**"CCO DRAFT"**  
 08/25/2010

**ROADWAY LIGHTING POLE AND FIXTURE SCHEDULES**  
**SHEET 2 OF 9**  
 NO SCALE

CONTRACT CHANGE ORDER No. 170  
 SHEET \_\_\_\_\_ OF \_\_\_\_\_

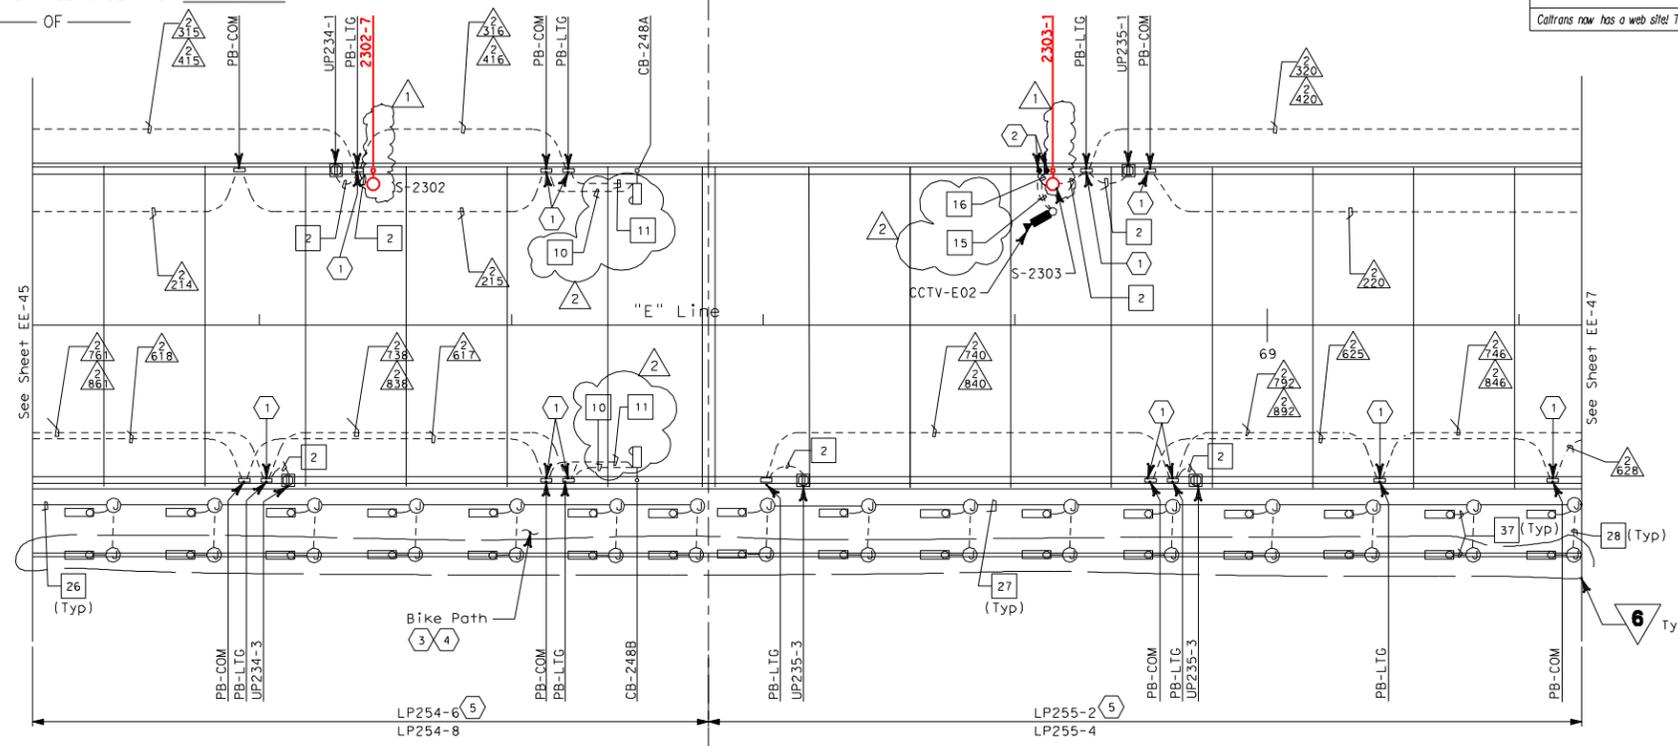
MARK	DATE	DESCRIPTIONS	REV	CK
2	1/20/06	Delete CB-248A & CB-248B. Coil 5 m of call box signal and power cable in adjacent PB-COM and PB-LTG pull boxes. Delete CCTV cable harnesses only.	JE	EJL
1	3/2/05	Delete Roadway light poles and fixtures. Coil 10m, 3#10 conductors in the pull box adjacent to light pole locations.	RS	PB

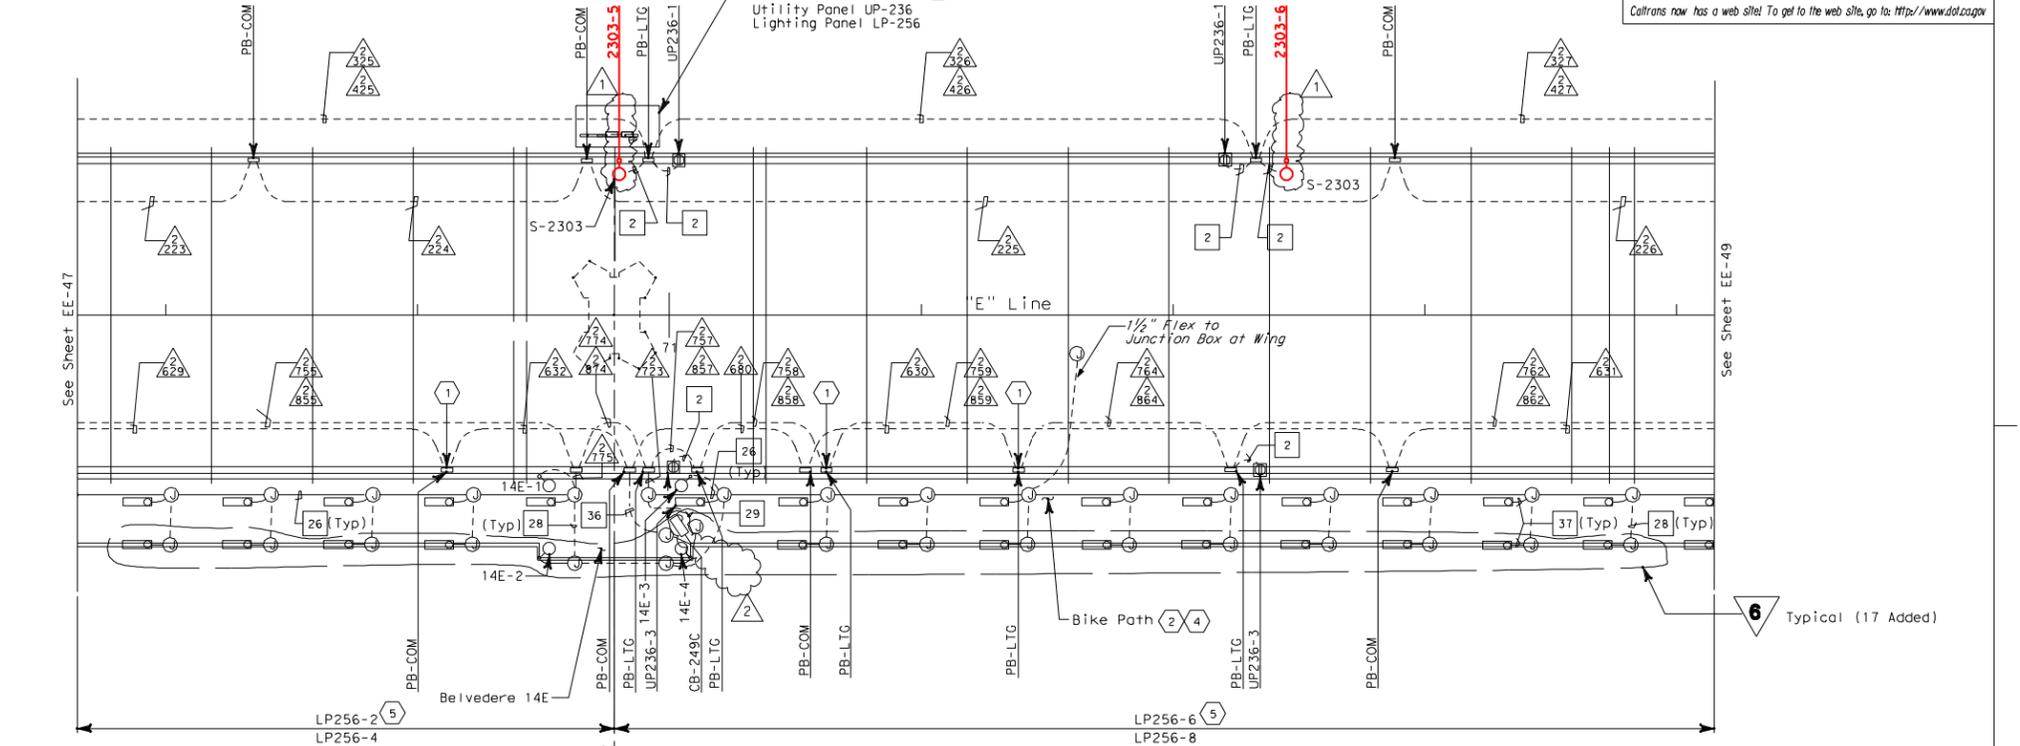
MARK	DATE	DESCRIPTIONS	REV	CK
2	1/20/06	Delete CB-249C. Coil 5 m of call box signal and power cable in adjacent PB-COM and PB-LTG pull boxes.	JE	EJL
1	3/2/05	Delete Roadway light poles and fixtures. Coil 10m, 3#10 conductors in the pull box adjacent to light pole locations.	RS	PB

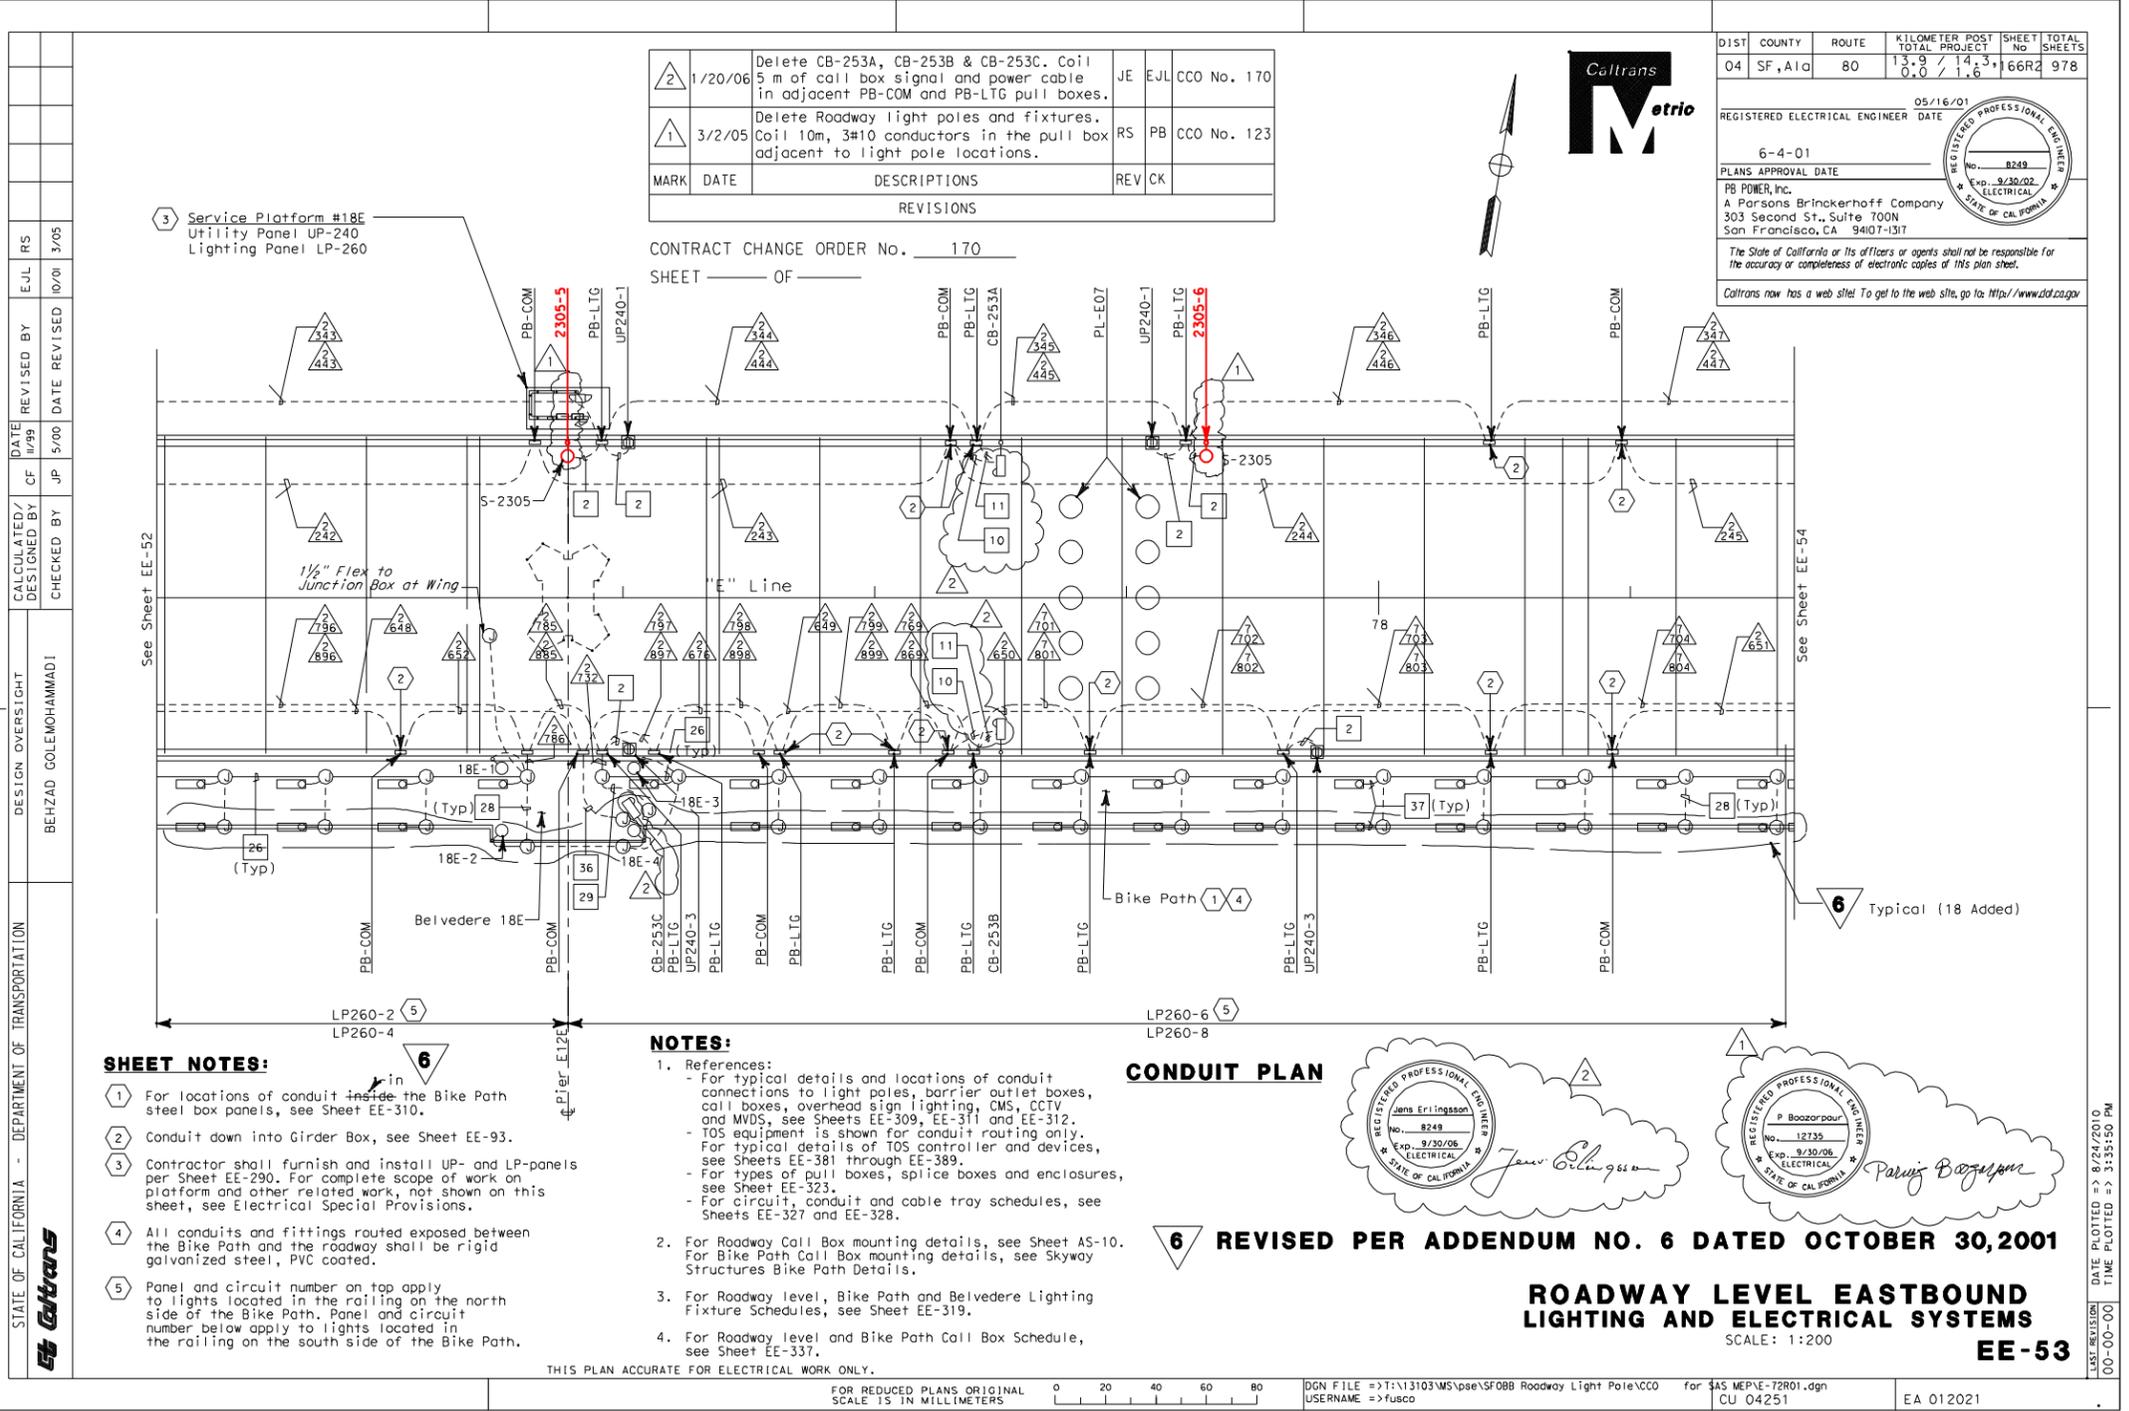
MARK	DATE	DESCRIPTIONS	REV	CK
2	1/20/06	Delete CB-253A, CB-253B & CB-253C. Coil 5 m of coil box signal and power cable in adjacent PB-COM and PB-LTG pull boxes.	JE	EJL
1	3/2/05	Delete Roadway light poles and fixtures. Coil 10m, 3#10 conductors in the pull box adjacent to light pole locations.	RS	PB

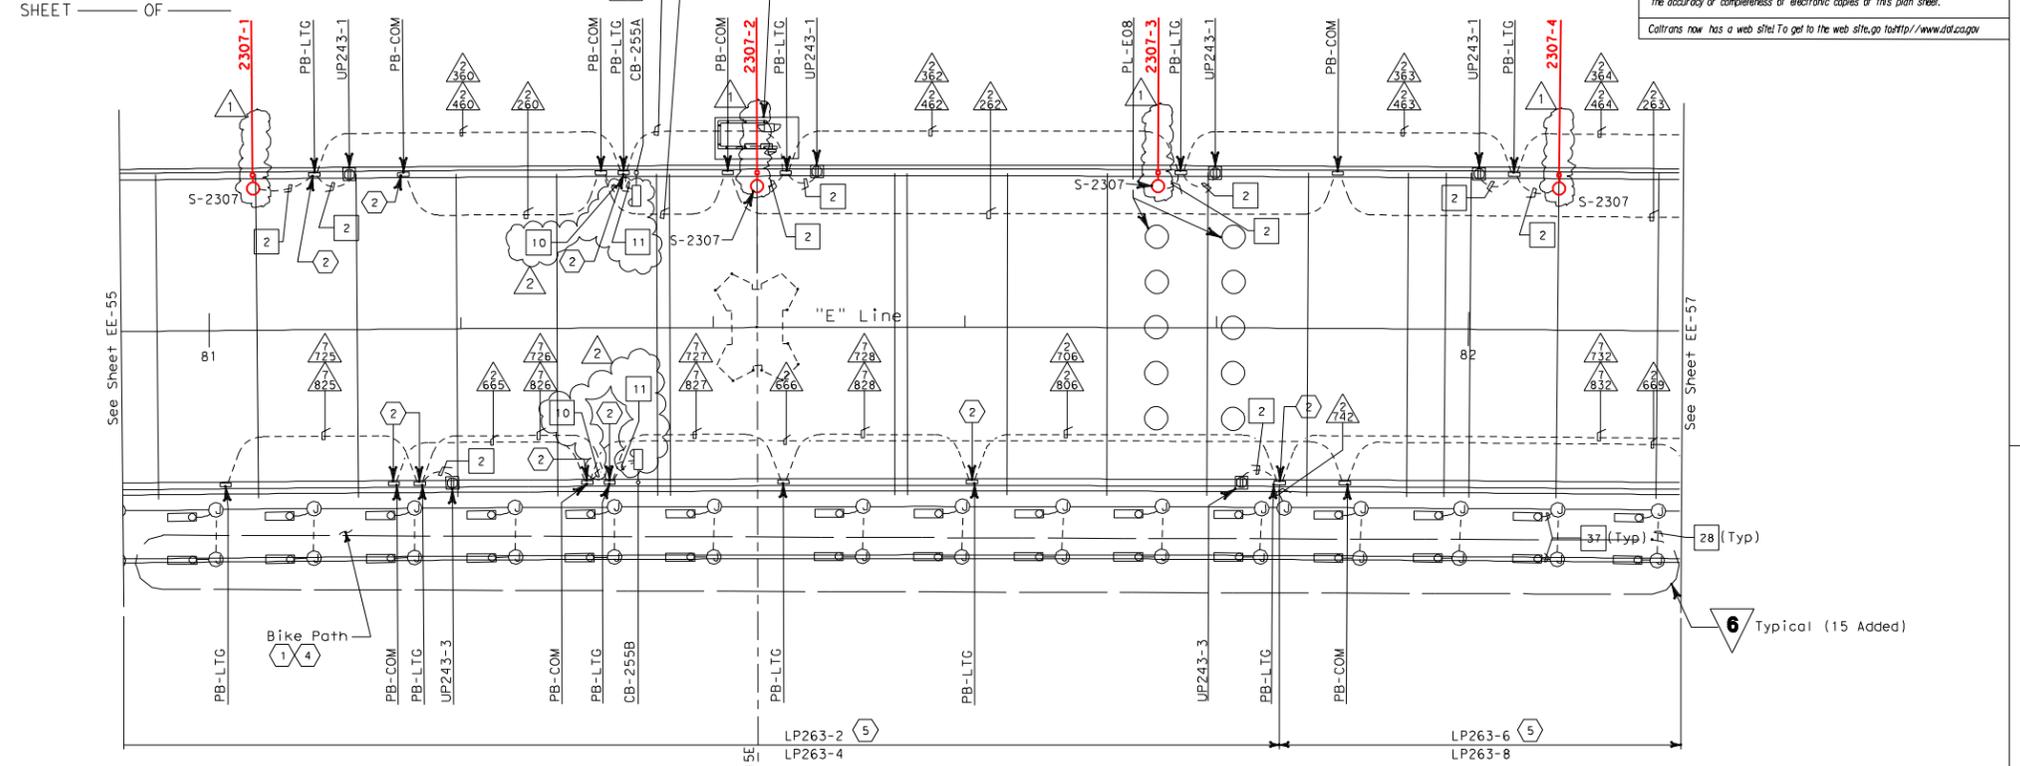
MARK	DATE	DESCRIPTIONS	REV	CK
2	1/20/06	Delete CB-255A & CB-255B. Coil 5 m of call box signal and power cable in adjacent PB-COM and PB-LTG pull boxes.	JE	EJL
1	3/2/05	Delete Roadway light poles and fixtures. Coil 10m, 3#10 conductors in the pull box adjacent to light pole locations.	RS	PB

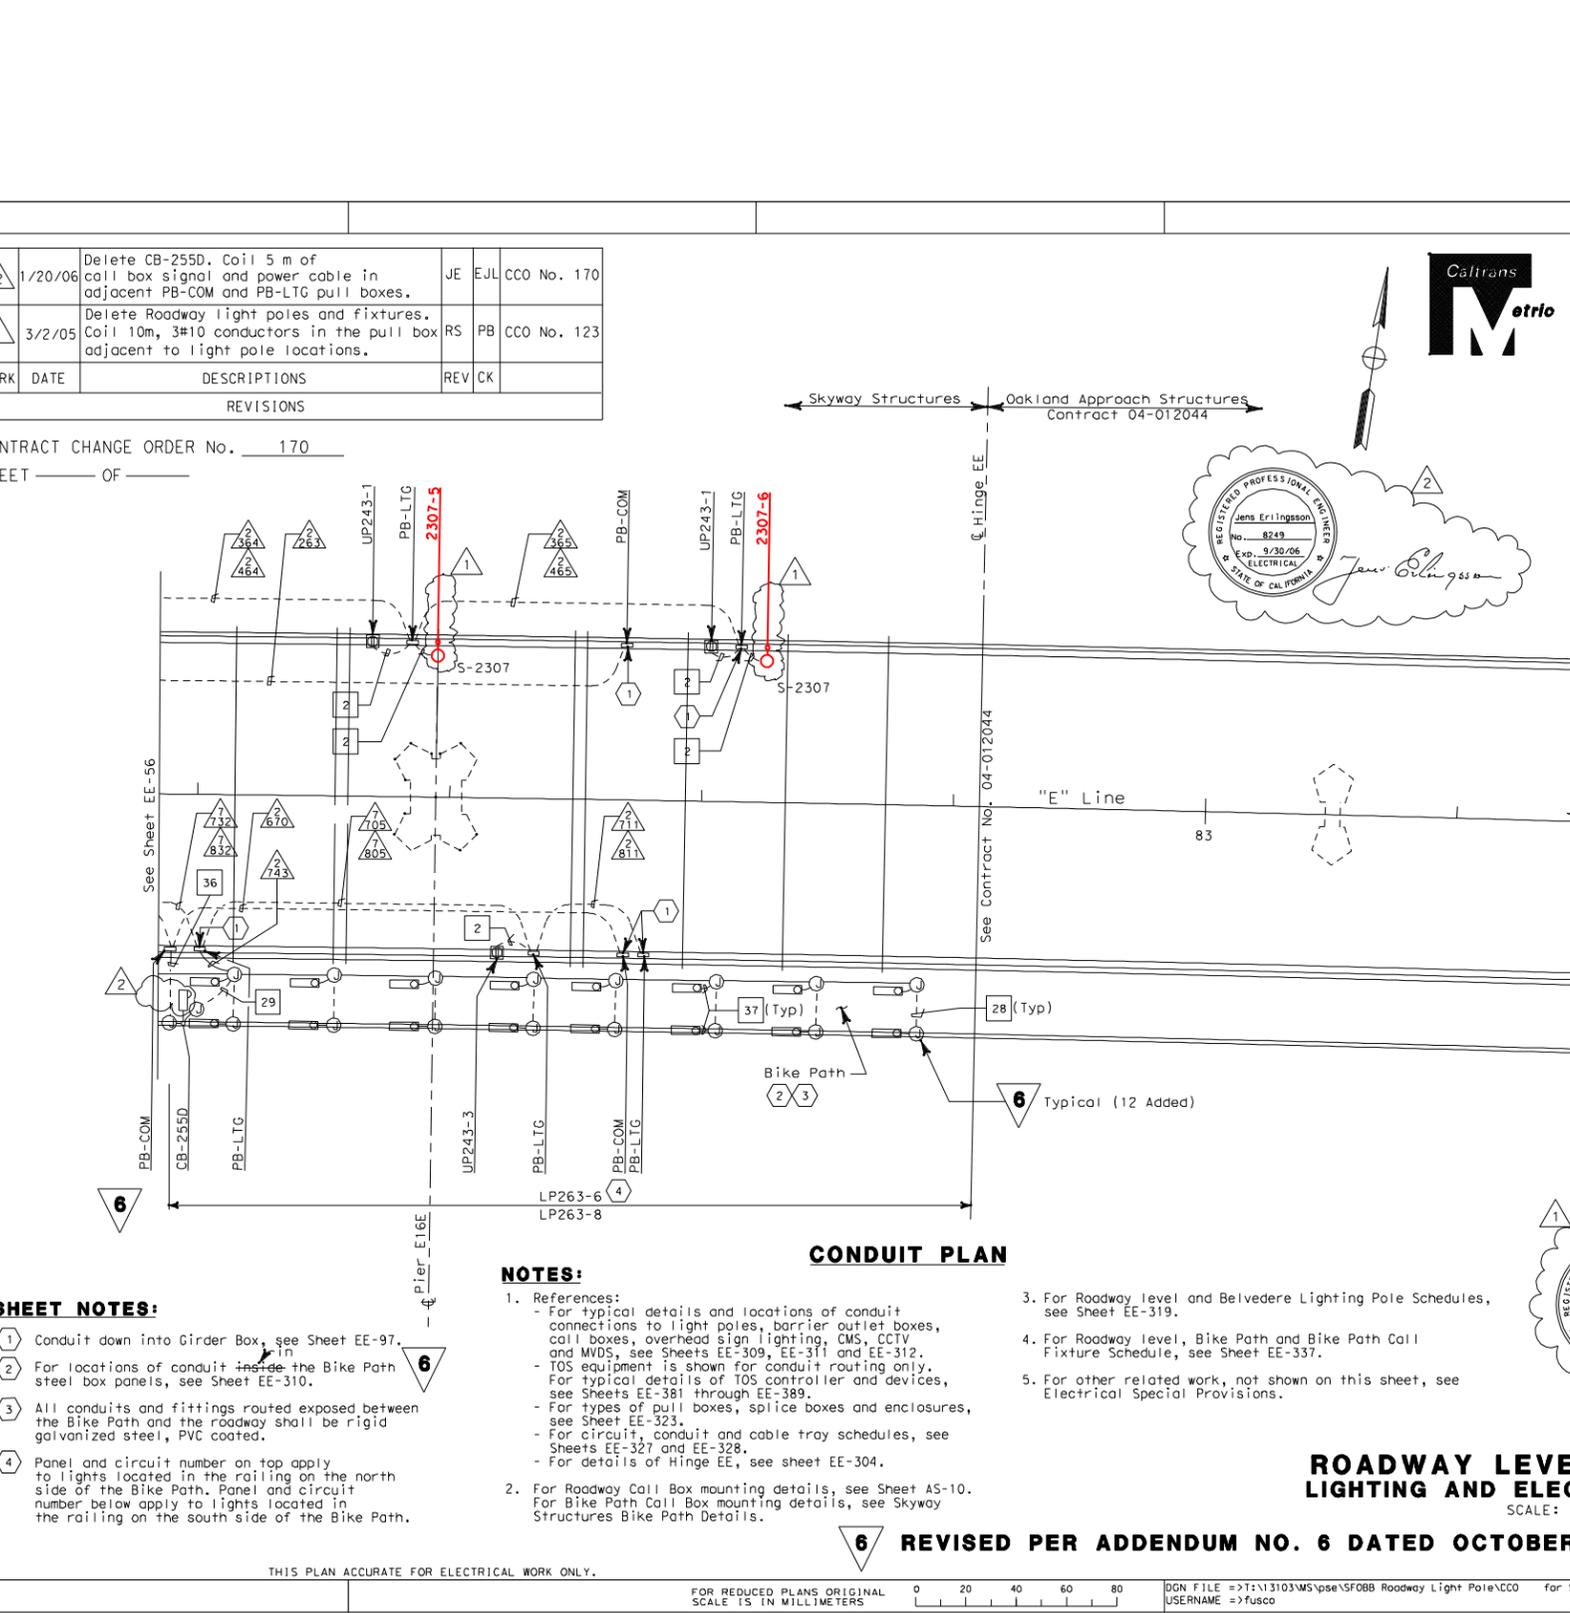
MARK	DATE	DESCRIPTIONS	REV	CK
2	1/20/06	Delete CB-255D. Coil 5 m of call box signal and power cable in adjacent PB-COM and PB-LTG pull boxes.	JE	EJL CCO No. 170
1	3/2/05	Delete Roadway light poles and fixtures. Coil 10m, 3#10 conductors in the pull box adjacent to light pole locations.	RS	PB CCO No. 123
